CALIFORNIA COASTAL COMMISSION

A-5- PPL-17-0030 (CHAN)

JULY 12, 2017

EXHIBITS

Figure 2. Geologic Map. 970 Chettanoogs Ave. This figure in modified in red from Green, et al. (op. cit., Pl. A)

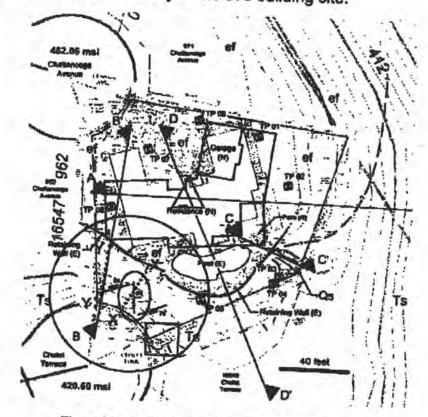
In the encircled area of Figure 2, the N55E bedding attitude is not apparent in the field. The square encloses the outcrops shown in Photo 1, The slope of the cul-de-sac cut is determined from the line X-X' which gives the cut slope horizontal component length scaled at 29.2 feet, and the length of the vertical component, taken as 31.6 feet, which is the difference of the cul-de-sac surface elevations from Khron (1982, Sheet 291), assuming the site elevation is the same as that of the Chattanooga Avenue cul-de-sac. As a result, the gradient of the cul-de-sac cut along X-X' section is 1.08, *i.e.*, 47.2 degrees from horizontal. Similarly, the gradient along the Y-Y' length of the B-B' geologic section is calculated as 0.87, *i.e.*, 41 degrees

Geologic sections A-A' through D-D' of Green, et al. (op. cit.) all show projected bedding planes, although no surface data are reported by which their orientations in the sections have been determined. As previously discussed, this certainly is true for Section B-B' which shows bedding planes with zero apparent dip out of the slope when straightforward application of Billings' apparent dip equation indicates one that such dip is significant. To illustrate the problem, a single example will suffice for present purposes.

In Figure 2, the added triangle in red shows where A-A' intersects D-D'. For the orientation of the bedding planes shown in those sections, either one or the other must be a true dip; otherwise, it cannot be determined whether the dips in one are consistent with dips in the other at the point of intersection. However, applying the equation of Billings (op. cit.) as discussed in Appendix A, Section 2.2.2, if Section A-A' gives the true dip, the apparent dip in D-D' would be 19 degrees, but applying Billings' equation gives 59 degrees. On the other hand, if D-D' gives the true dip, the appar-

ent dip in A-A' would be 57 degrees rather than the 25 degrees shown. Consequently, bedding plane orientations in the geologic sections given by Green, et al. (op. cit.) are without technical significance.
